1st Further Information

**Proposed Temporary Open Storage of Construction Materials and Machinery
and Associated Filling of Land for a Period of 3 Years in "Agriculture" Zone,
Lots 36, 37 (Part) and 38 (Part) in D.D. 38, Man Uk Pin, New Territories**

(S.16 Planning Application No. A/NE-MUP/231)

Response-to-Comment (RtC)

Revised plan showing the Filling of Land at the Site

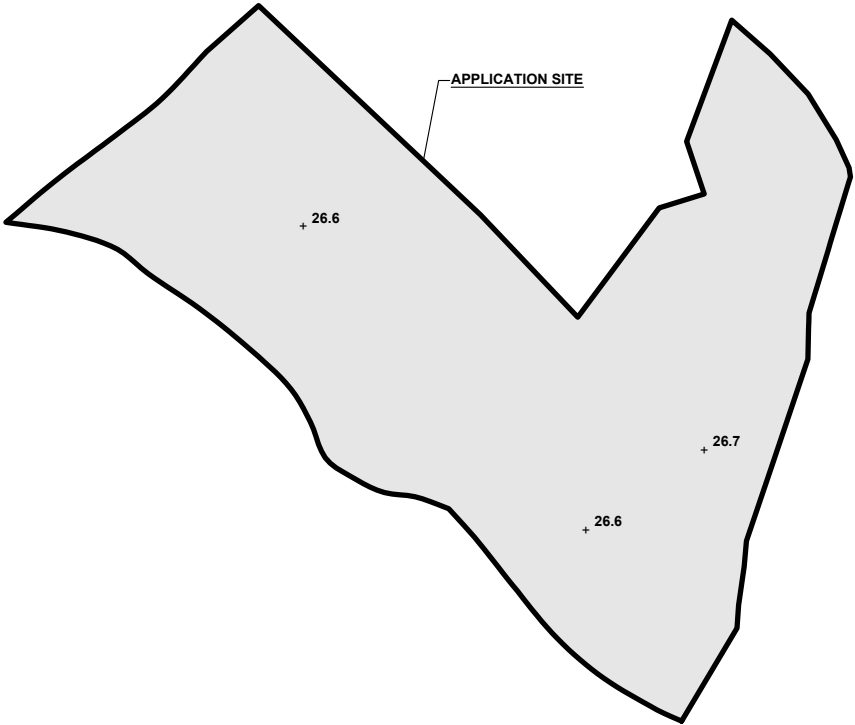
(a)	Please clarify the current site level and surface condition.	Majority of the Site is currently hard-paved, while the remaining area is covered by soil. The current site level and surface condition are reflected at the revised plan showing the filling of land area at the Site (Annex 1). The Site is proposed to be hard-paved wholly with concrete of not more than 0.2 m in depth for open storage area, and vehicle parking, L/UL and circulation area (Annex 1). Upon completion of the proposed filling of land, the site levels will range between +26.6 mPD and +26.7 mPD.

(b)	Whether any further filling of land would be carried out under the captioned planning application.	The site formation is considered necessary to meet the operational need and the extent of filling has been kept to a minimum. The applicant will strictly follow the proposed scheme after planning permission has been granted from the Board.

FIGURE NUMBER
FIGURE 3

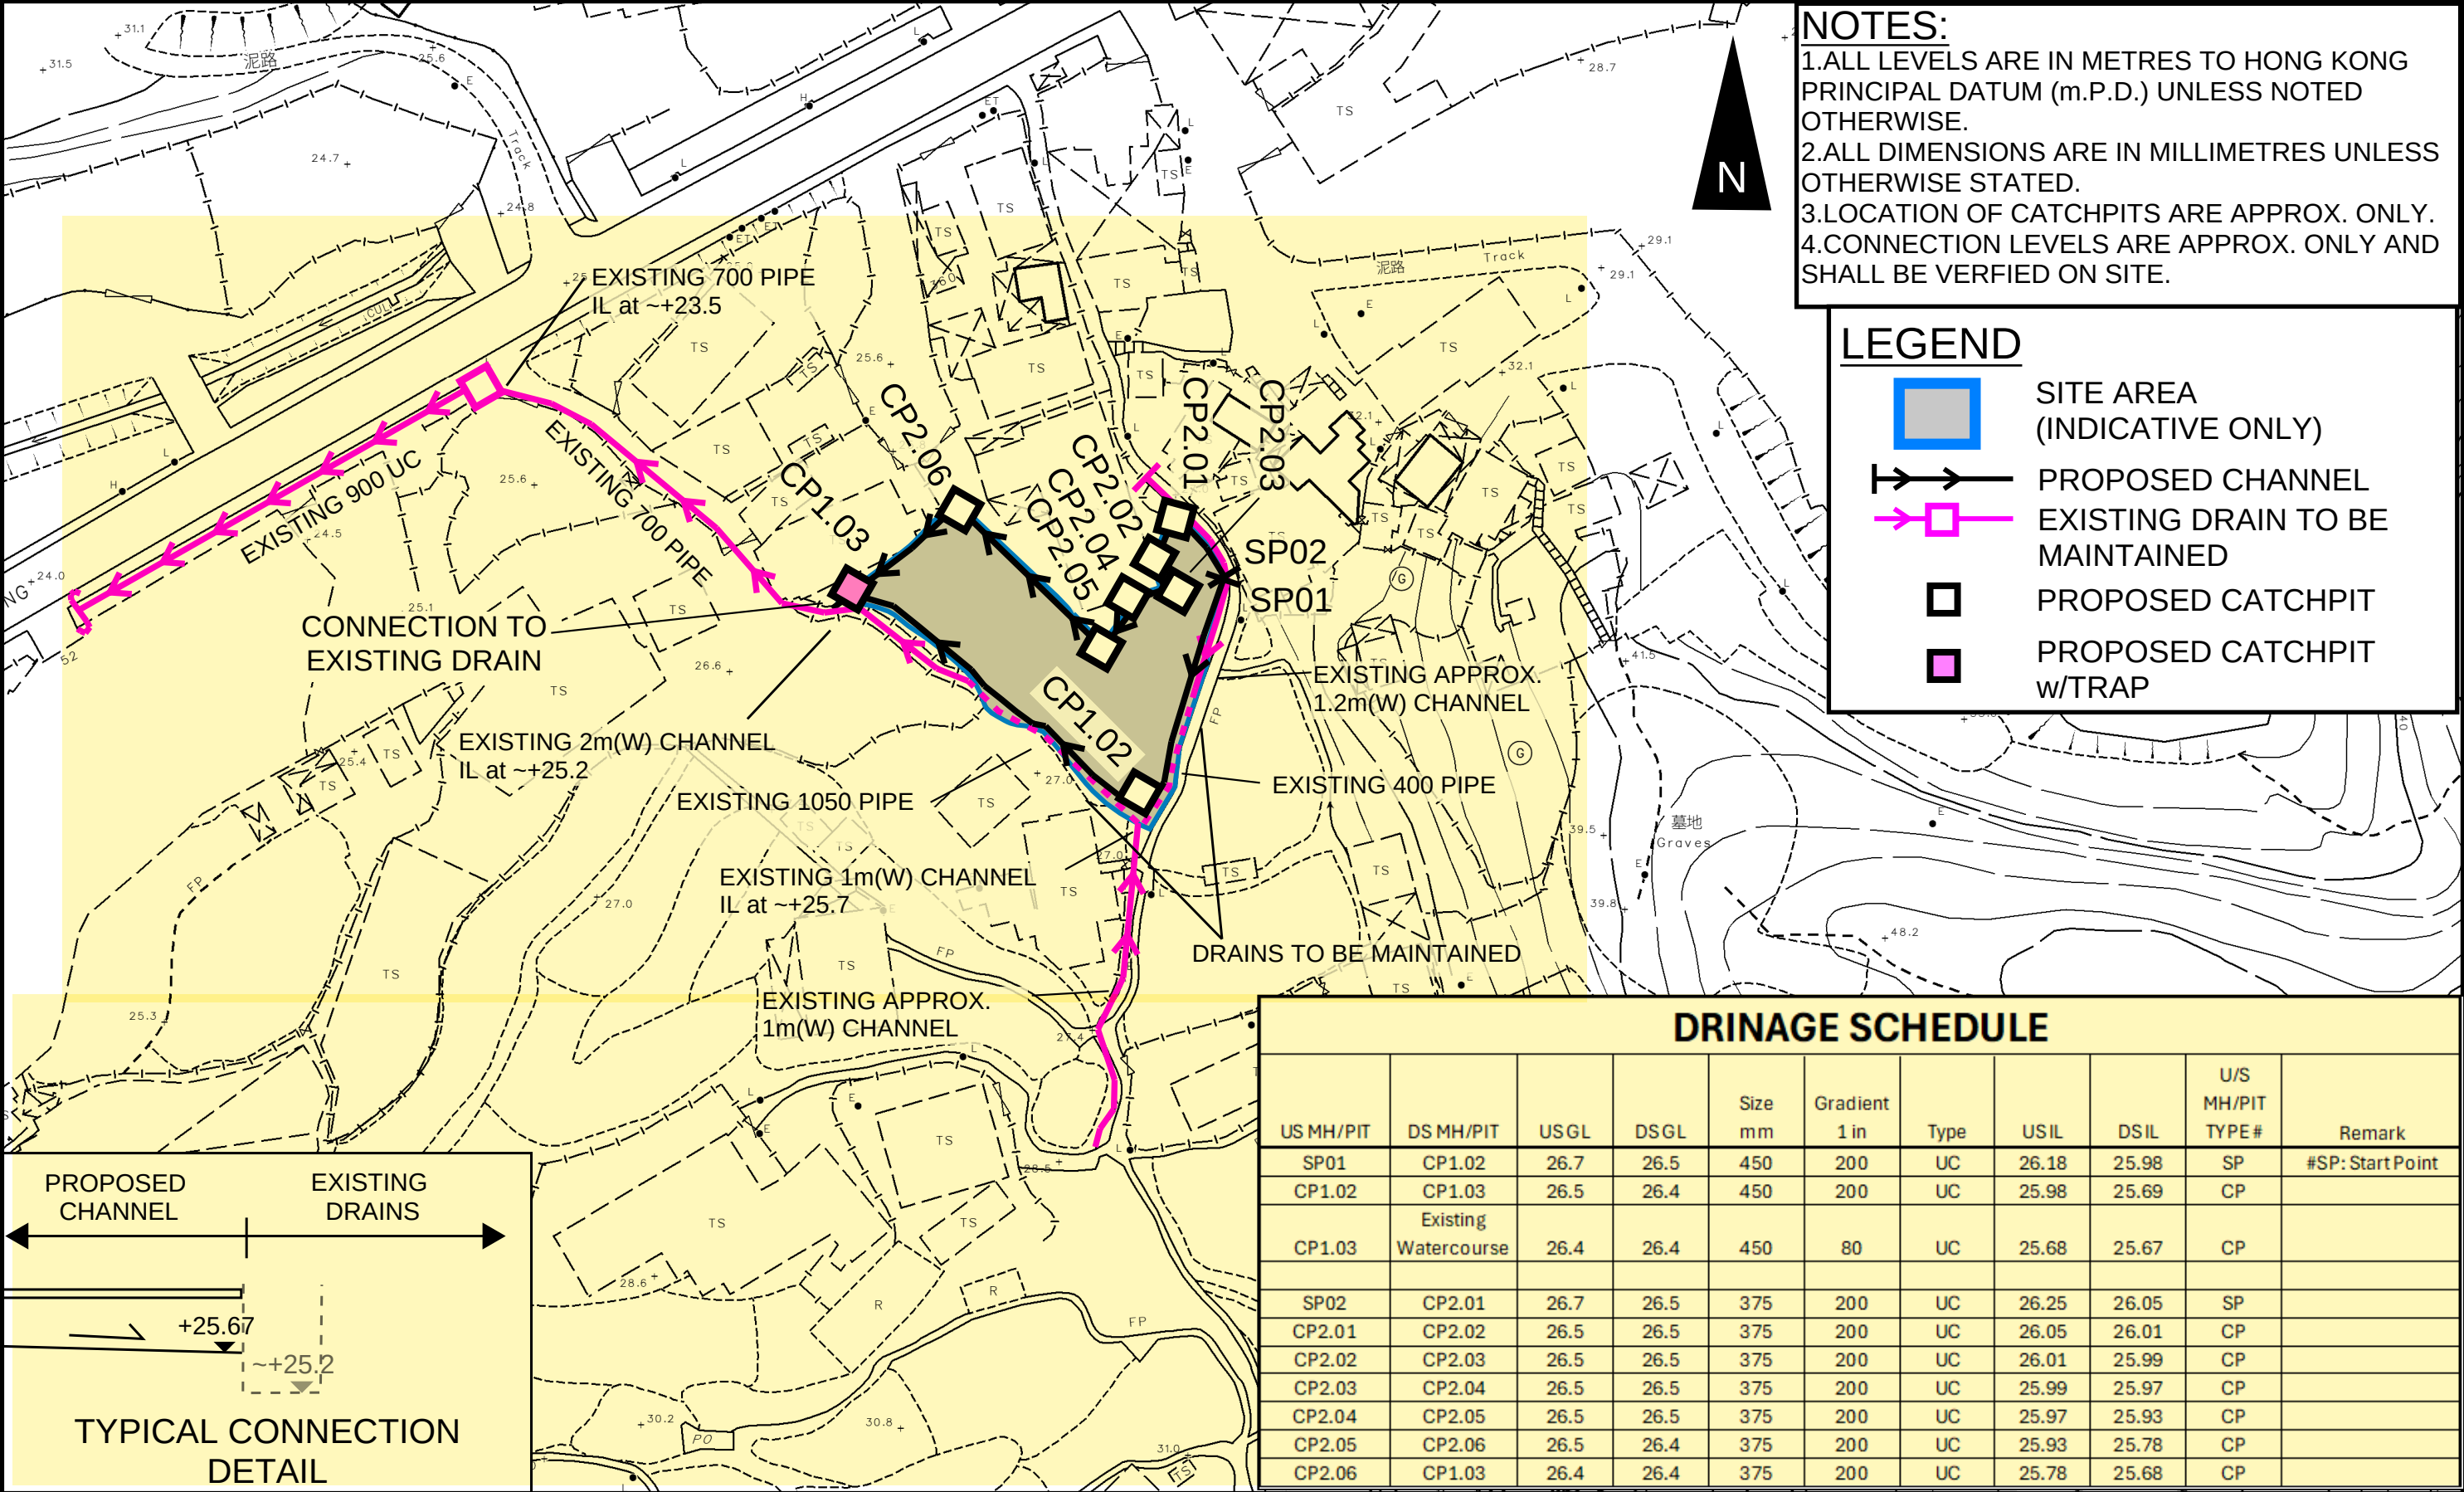
(n)	<u>Specific Comments</u> Section 1.2.3: the applicant should supplement details of the existing watercourses (e.g. dimension, gradient, invert level etc.), and site photos showing the condition of the watercourses;	Noted. Please find supplement details of existing watercourse in Figure 3 for your perusal. Photos are shown in Appendix D of Annex 2 .

(o)	Figure 3 refers: (i) the alignment of drainage facilities between CP2.01 to CP2.05 is unclear. The applicant should review the scale of this figure; (ii) detail A: the applicant should indicate the details of drainage facilities connecting the inlet structures and the catch pits (e.g. type, dimension, gradient, invert level, etc.). Invert levels of the existing watercourse and the inlet structures should also be indicated. Section of detail A should be supplemented; (iii) catchpit should be provided at each location of a change of flow direction of the proposed u-channel; (iv) thickness of concrete cover/grating should be considered when determining the invert levels of catch pits and u-channels to ensure the depths of u-channels are adequate. For instance, the depth of UC at SP01 is less than 375mm; (v) drainage schedule: there are 2 inlets at CP1.01 and CP1.02. The applicant should indicate the invert levels of both inlets in the schedule; and	Noted. Figure 3 is updated for your perusal. Please kindly note the details of existing watercourse are updated in Figure 3. The existing watercourse are proposed to be maintained. The proposed drains would be connected to existing watercourse at CP1.03 only. Noted. Catchpits are provided at each turning point. Noted. Channel cover thickness is considered in updated drainage schedule and Appendix A of Annex 2. Please kindly note the drainage arrangement is revised. The existing drains are surrounding the site at eastern and southern boundary. The existing drains are proposed to be maintained. The proposed drains would be connected to existing drains at CP1.03 only.

(vi) the applicant should indicate whether grating/cover will be provided for the proposed UC;	Noted. Covers are to be provided for the proposed UC.
(p)	Figure 4: the surface runoff collected by the UC connecting CP1.03 and the existing manhole should be considered; and	Please kindly note the drainage arrangement is revised. Existing 700mm underground pipe is proposed to be used to connect to the existing 900mm channel at Sha Tau Kok Road.
(q)	the applicant should supplement typical details of catch pit without trap.	Noted. Appendix C of Annex 2 is updated for your perusal.
